Report of the Bulletins and Orders Task Force

NUREG-0645

APPENDICES

- A - OFFICE OF INSPECTION AND ENFORCEMENT BULLETINS
- B - NRR STATUS REPORT ON FEEDWATER TRANSIENTS IN BWR PLANTS
- C - ORDERS ON BABCOCK & WILCOX COMPANY PLANTS
- D - LETTERS LIFTING ORDERS
- E - LETTERS ISSUING AUXILIARY FEEDWATER SYSTEM REQUIREMENTS
- F - LETTER TO LICENSEES OF ALL OPERATING REACTORS, DATED OCTOBER 30, 1979 CONCERNING SHORT-TERM LESSONS LEARNED REQUIREMENTS
- G - LETTERS APPROVING GUIDELINES FOR PREPARATION OF SMALL-BREAK LOCA OPERATING PROCEDURES

Figure 1

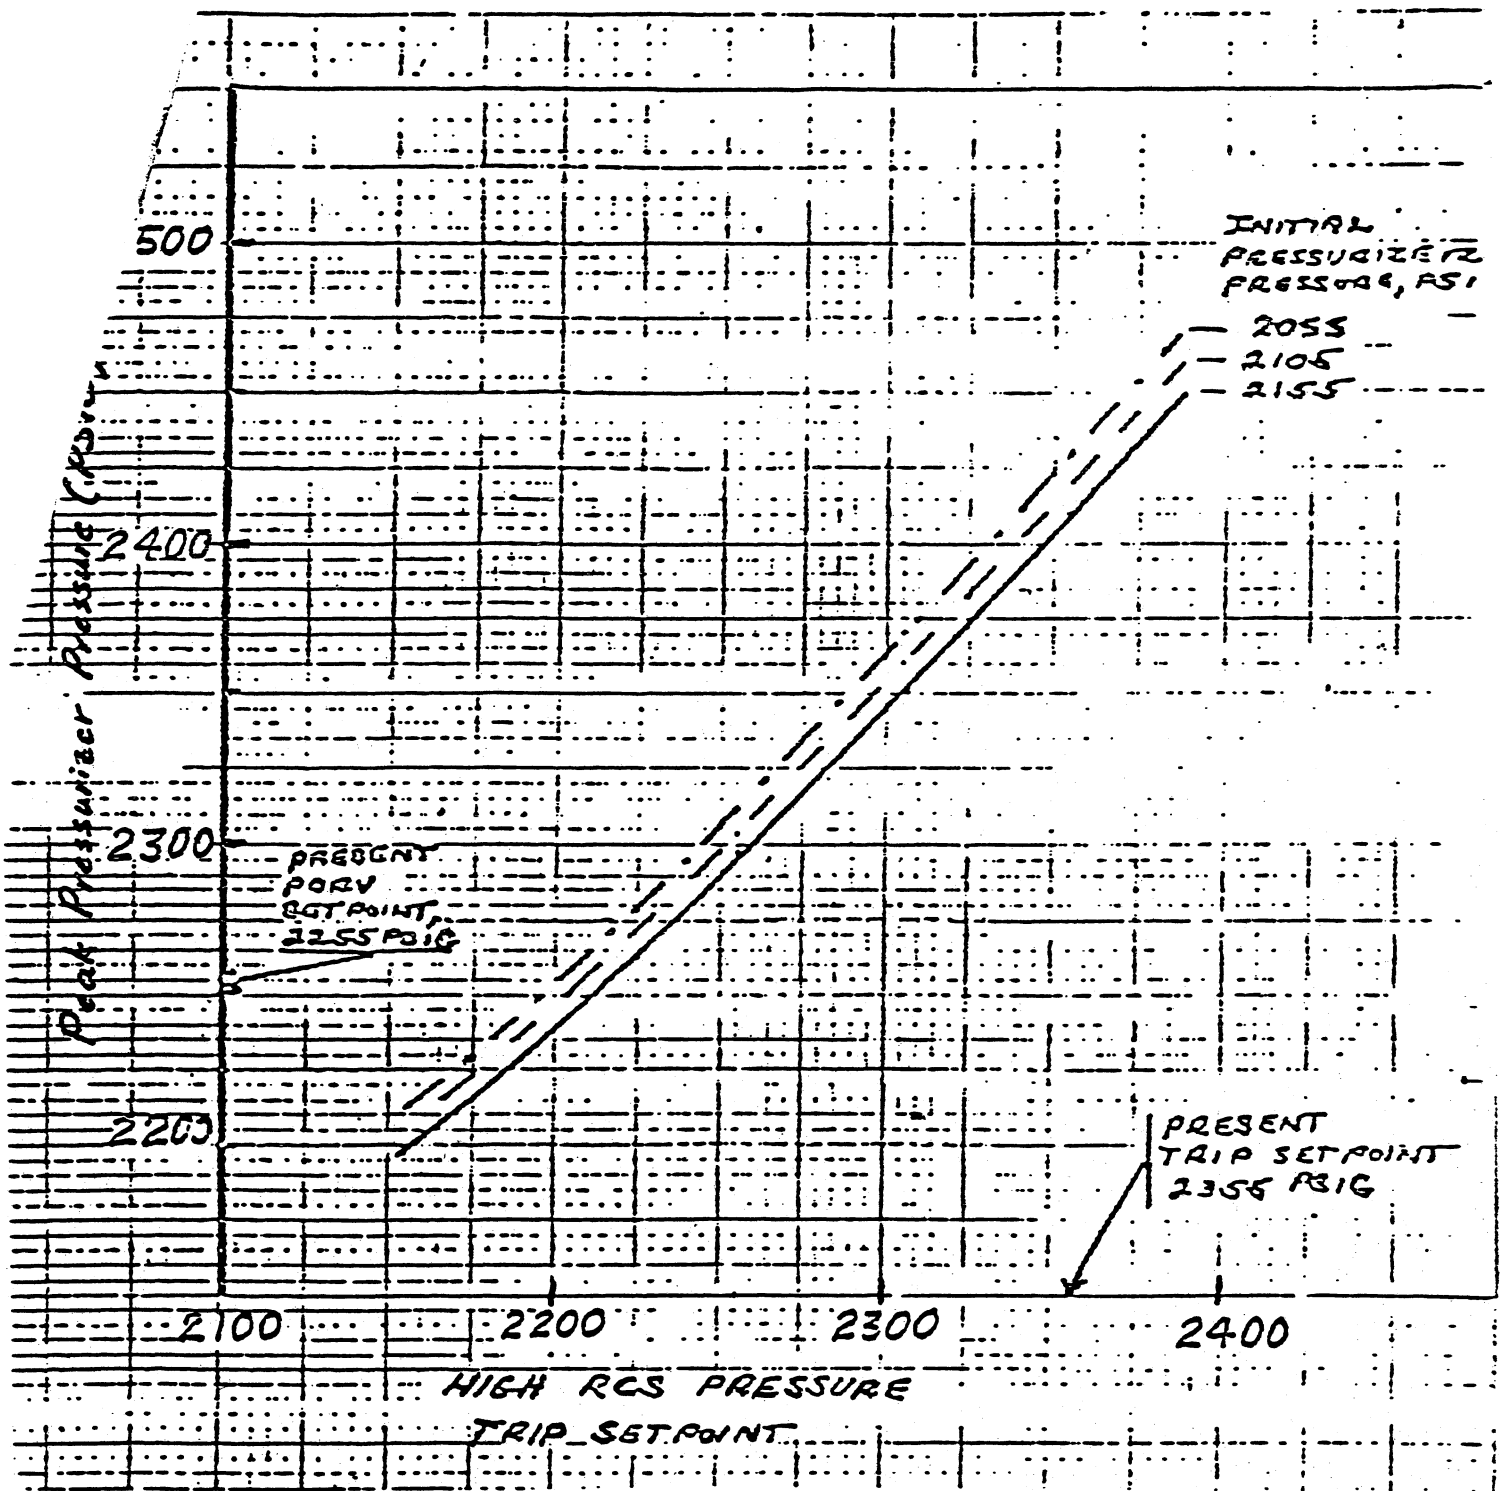
The effect of changing the reactor coolant system pressure trip setpoint upon peak pressurizer pressure is typified by the attached figure 1. which was developed by B&W for a loss of feedwater transient.

Auxiliary Feedwater System
Calvert Cliffs, Unit 1 & 2
Figure 1

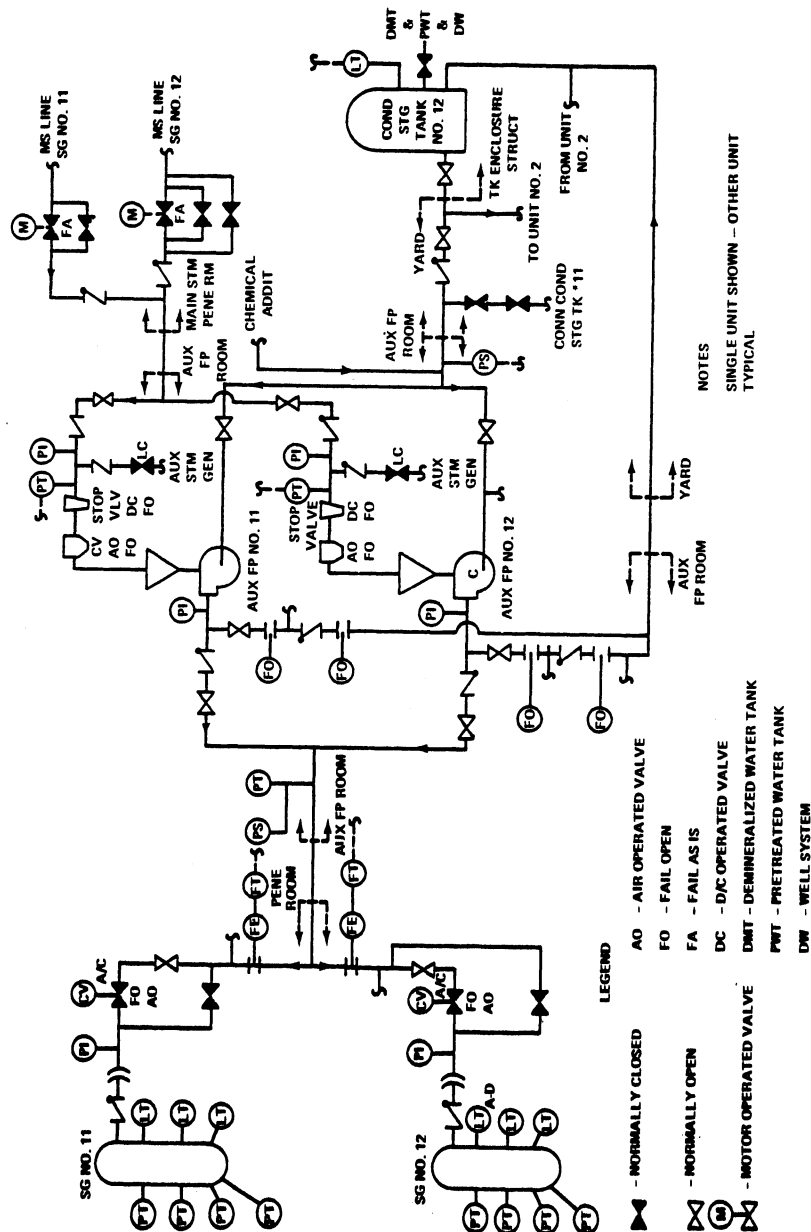
- a) The AFW pump discharge lines and turbine driven AFW steam supply lines combine into different single lines through which all AFW water or steam must flow. (See Figure 1). A pipe break in either of these single flow paths would cause loss of the entire AFW function.
- b) The Calvert Cliffs AFW systems do not meet the high energy line break criteria in SRP 10.4.9 and Branch Technical Position 10-1; namely, that the AFW system should maintain the capability to supply the required flow to the steam generator(s) assuming a pipe break anywhere in the AFW pump discharge lines concurrent with a single active failure.

Auxiliary Feedwater System
Maine Yankee
Figure 1

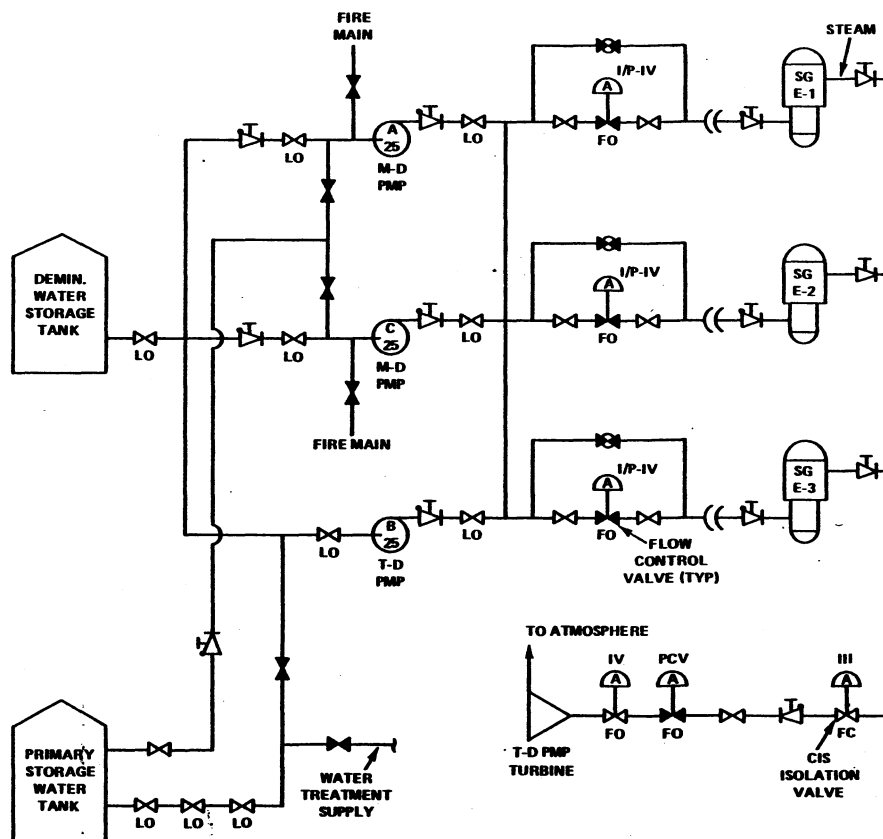
The steam for the turbine-driven pump is received from the main steam system via a series of valves as shown in Figure 1. Three of these valves are pneumatic diaphragm air-operated valves. One of these air-operated valves fails closed and is designed to close on high containment pressure (5 psig). The other two air-operated valves fail open; one receives its control power from the Division IV vital AC bus and the other from a DC bus.
